SUBDIVISION AUTHORITY MINUTES MEETING NO. 20

File No. LDA22-0112

RE: Tentative plan of subdivision to create 7 single detached residential lots from Lot 267, Block 1, Plan 152 5690, and Lot 268, Block 1, Plan 152 5690, and a portion of road closure area, located west of 170 Street SW and south of 9B Avenue SW; **WINDERMERE**

File No. LDA21-0500

SUBDIVISION CONDITIONS OF APPROVAL MAP

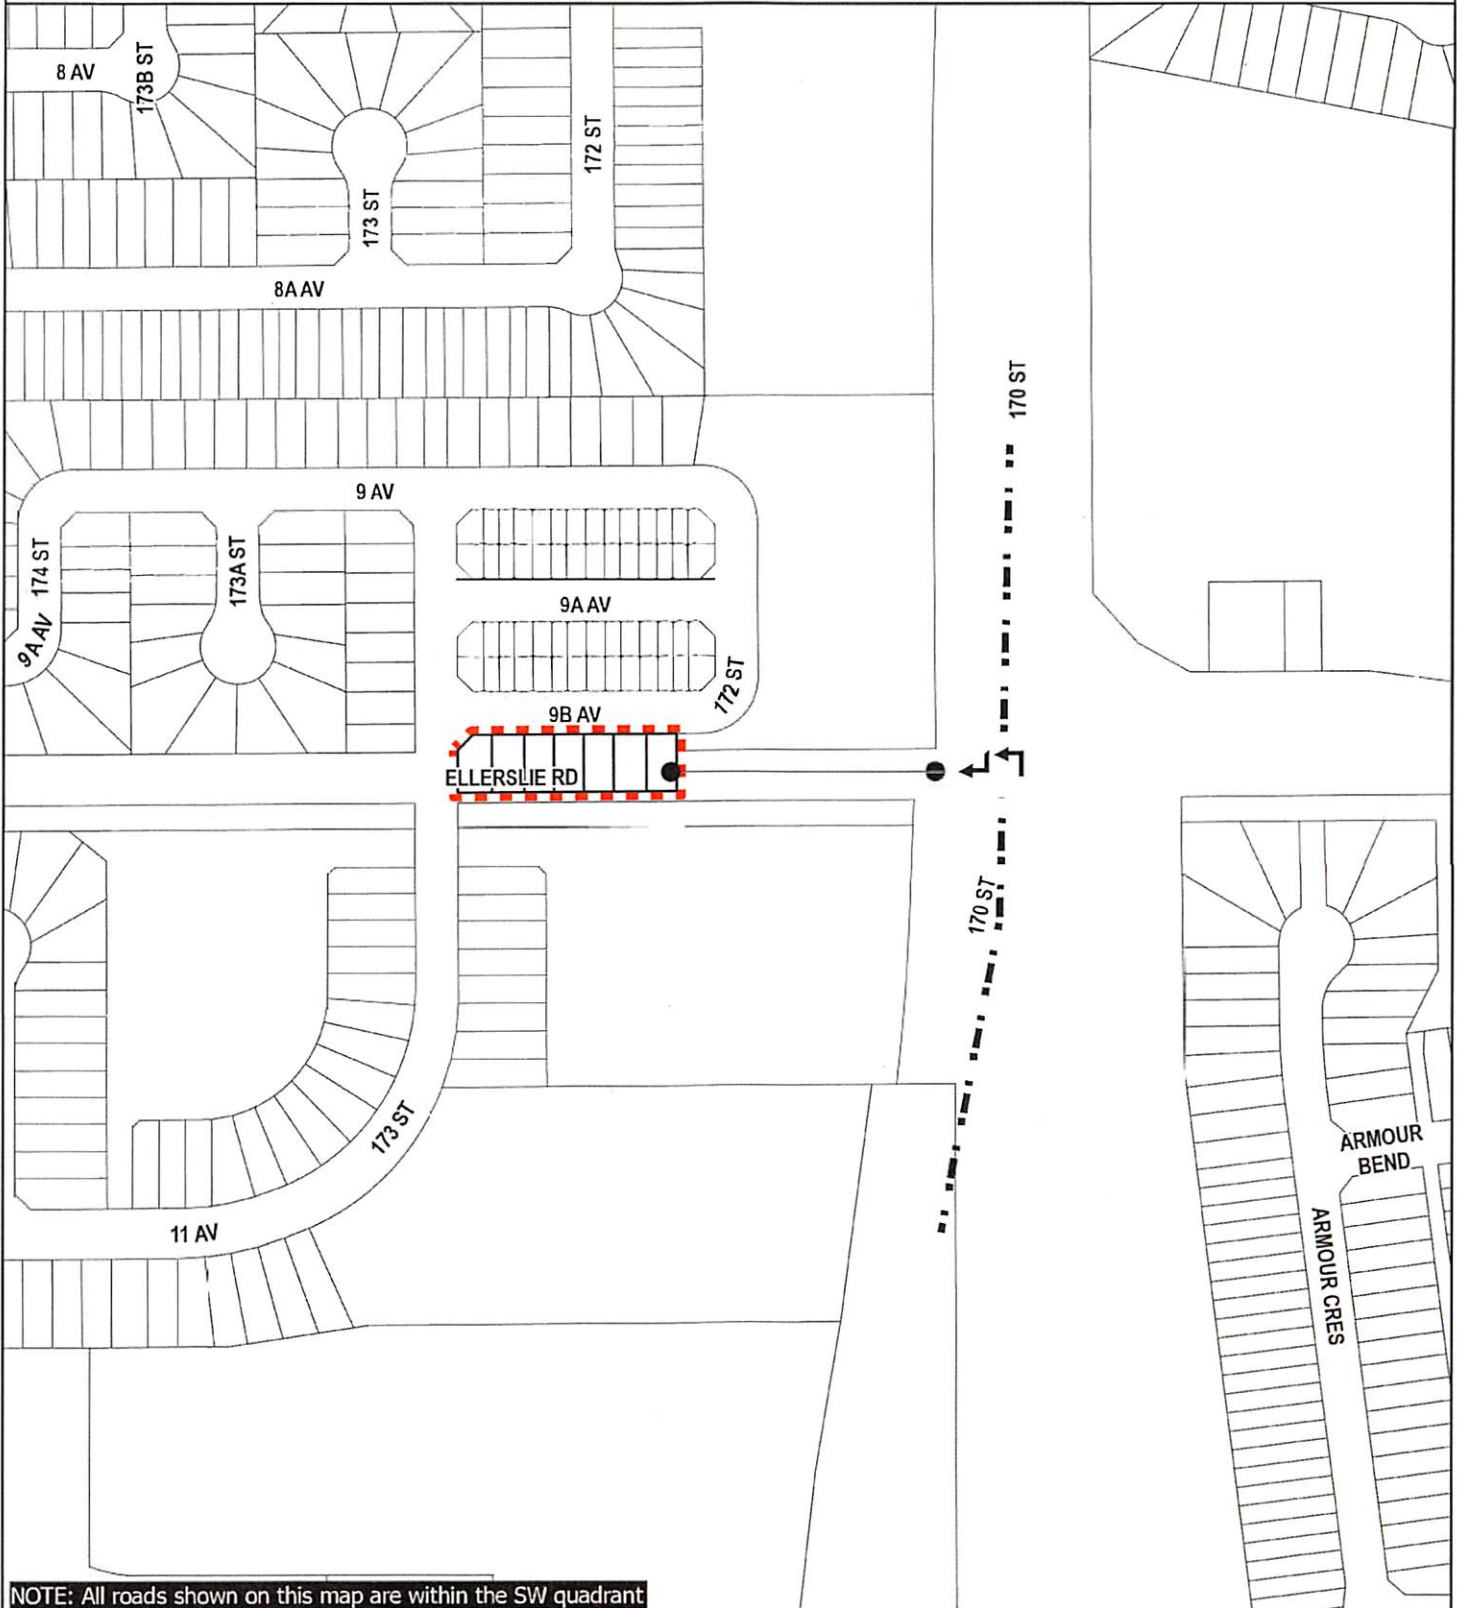
7. that the owner remove the road structure of the existing Ellerslie Road SW roadway from 170 Street SW to 173 Street SW, to the satisfaction of Subdivision and Development Coordination, as shown on Enclosure I. This will include the remediation of the road closure area, removal of the road structure, re-grading of the land, landscaping and any utility relocation/modification deemed necessary as a result of the closure;

8. that the owner construct 173 Street SW to a local roadway Complete Streets design and cross section, between the north and south side of Ellerslie Road SW, to complete the missing urban section of roadway, including sidewalks and curb ramps, to the satisfaction of Subdivision and Development Coordination, as shown on Enclosure I;

12. that the owner construct all fences wholly on privately-owned land, to the satisfaction of Subdivision and Development Coordination, as shown on the "Conditions of Approval" map, Enclosure I; and

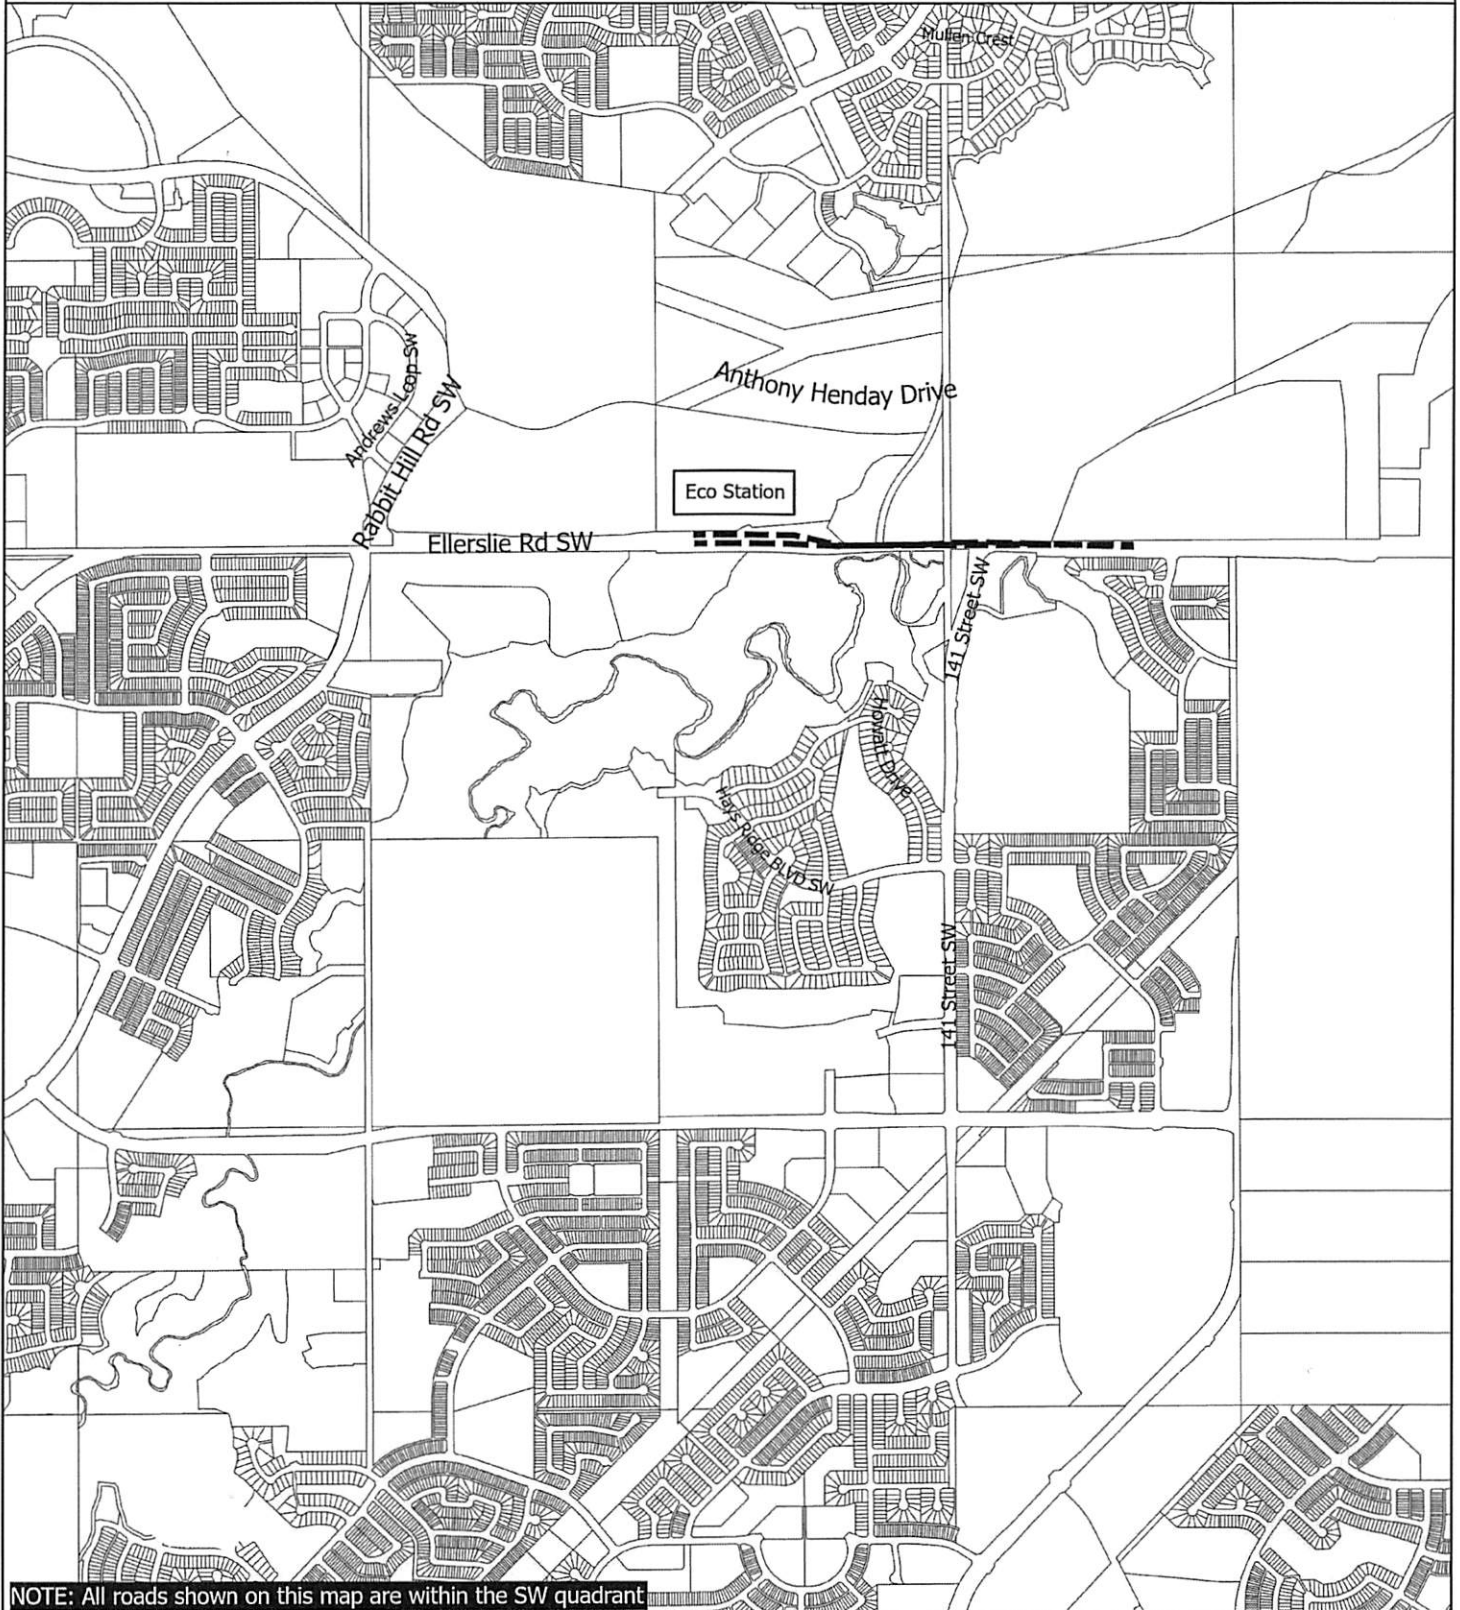
9. that the owner make modifications to 170 Street SW, including the removal of the west leg of the intersection at Ellerslie Road SW, construction of the curb and gutter along the west side of 170 Street SW, removal of southbound right turn bay and the northbound left turn bay at Ellerslie Road SW, median construction and/or reconstruction, channelization, utility relocation/modification, landscaping, paint line marking modifications and any transitional improvements, to the satisfaction of Subdivision and Development Coordination, as shown on Enclosure II;

11. that the owner provides an alternate drainage system to manage the surface flow from the temporary ditch which currently runs through the proposed subdivision area, to the satisfaction of Subdivision and Development Coordination, as shown on Enclosure II;

SUBDIVISION CONDITIONS OF APPROVAL MAP

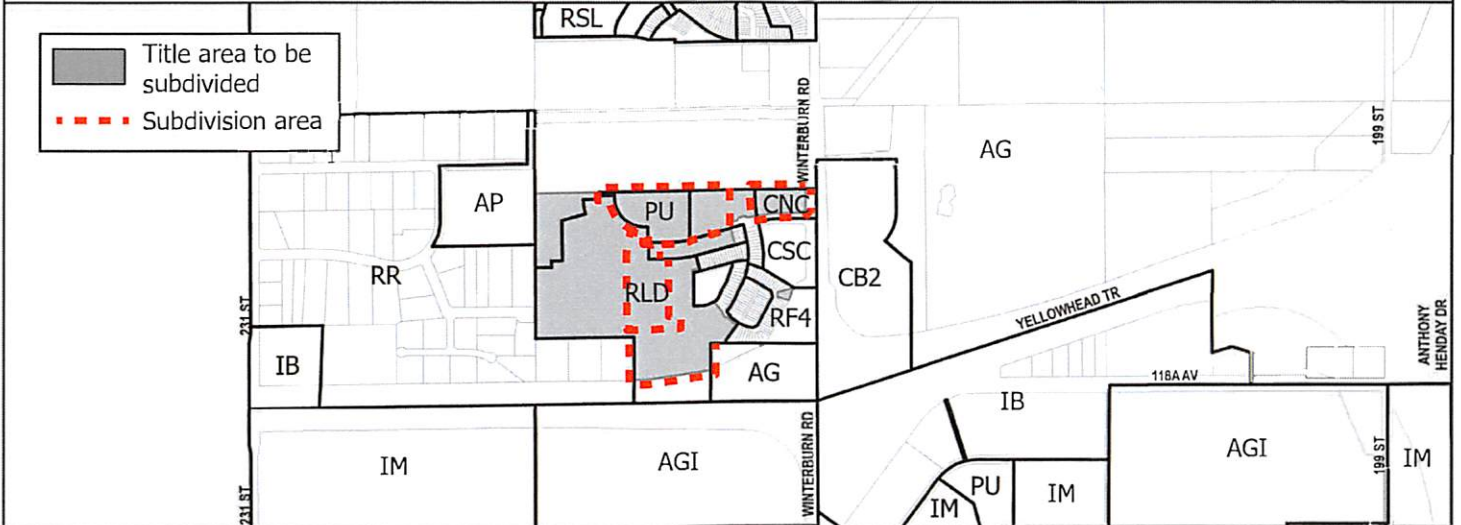
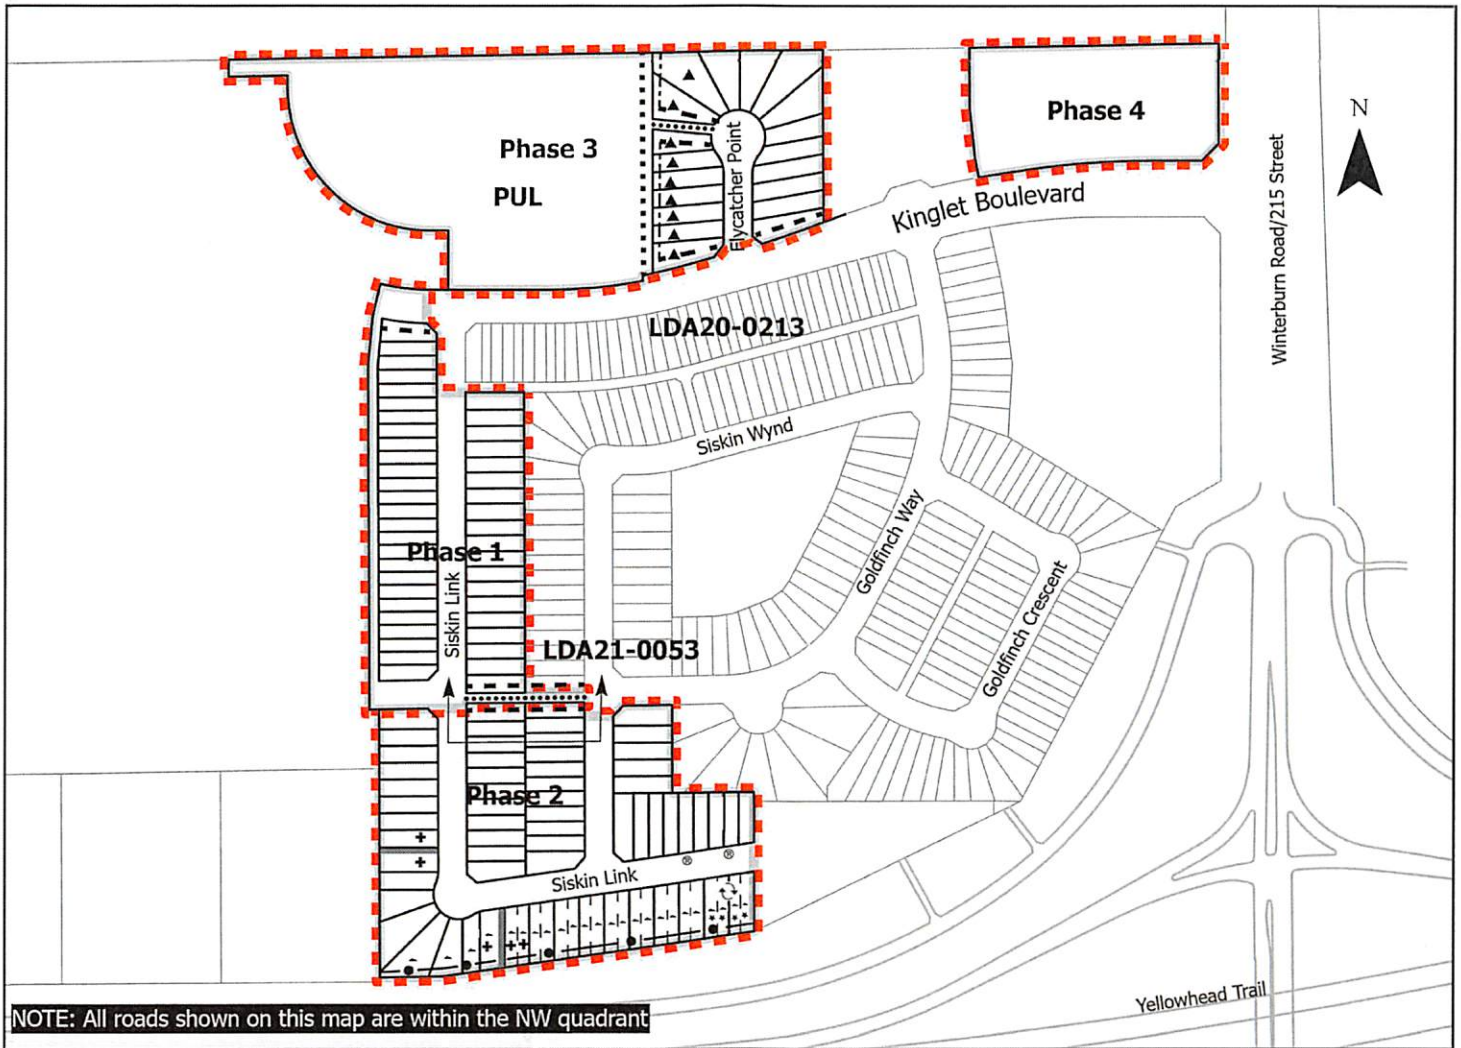
3. that the owner register easements on the residential lots for the provision of underground storm sewers on private property, as shown on the "Conditions of Approval" map, Enclosure I;

4. that the lot(s) identified be withheld from registration until the temporary turnaround is no longer required as deemed by Subdivision and Development Coordination, as shown on the "Conditions of Approval" map, Enclosure I;

9. that the owner construct a temporary 12 m radius paved surface turnaround with bollards or mini-barriers to the satisfaction of Subdivision and Development Coordination, as shown on the Enclosure. This turnaround will be required prior to CCC for roads (or at the discretion and direction of Subdivision and Development Coordination);

10. that the owner constructs a temporary 6 m gravel surface roadway connection to the satisfaction of Subdivision and Development Coordination, as shown on the "Conditions of Approval" map, Enclosure I. This roadway will also serve as a temporary emergency access roadway and is required prior to Construction Completion Certificate (CCC) for roads (or when required by Subdivision and Development Coordination);

11. that the owner constructs a 3 m hard surface shared use path with bollards and lighting, adjacent to the Storm Water Management Facility (SWMF) with connections to future adjacent shared use paths, as per City of Edmonton Design and Construction Standards, to the satisfaction of Subdivision and Development Coordination, as shown on the "Conditions of Approval" map, Enclosure I;

12. that the owner constructs a 1.8 m concrete sidewalk with lighting and bollards within the walkways, with connections to the adjacent shared use path and sidewalks, to the satisfaction of Subdivision and Development Coordination, as shown on the "Conditions of Approval" map, Enclosure I;

13. that the owner pays for the installation of "no parking" signage on Siskin Link NW, to accommodate the turning movements of waste management vehicles, to the satisfaction of Subdivision and Development Coordination, as shown on the "Conditions of Approval" map, Enclosure I;
